Note Proposed Amendments: (added text to the code is: underlined, deleted text to the code is: ~~struck through~~)

\*Note: These amendments are “proposed only” and have not been adopted by the Department of Community Affairs.

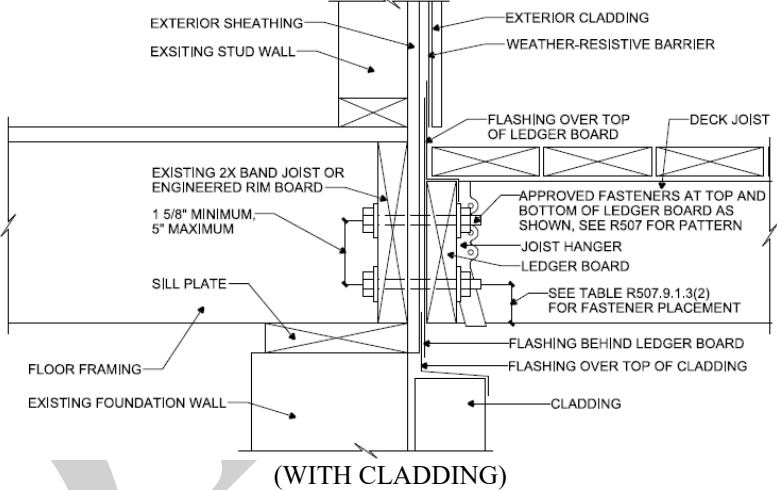
IRC-2024-26	R323.1	<p>Revise Section R323.1 ‘Elevators’ and add a new Section R323.1.1.3 ‘Hoistway opening framing’ to read as follows:</p> <p><b><u>R323.1 Elevators.</u></b> Where provided, <del>passenger elevators,</del> limited-use and limited-application elevators or private residence elevators shall comply with ASME A17.1/CSA B44.</p> <p><b><u>R323.1.1.3 Hoistway opening framing.</u></b> <del>Passenger elevators,</del> limited-use/limited-application elevators or private residence elevators shall have hoistway landing openings that meet the Georgia amended requirements of ASME A17.1/CSA B44 Sections 5.3.1.1 and 5.3.1.7.2. The clearance between the hoistway doors or gates and the hoistway edge of the landing sill shall not exceed 3/4 inch (19 mm). The distance between the hoistway face of the landing door or gate and the car door or gate shall not exceed 3 inches (75 mm).</p>	2020 amendments	R
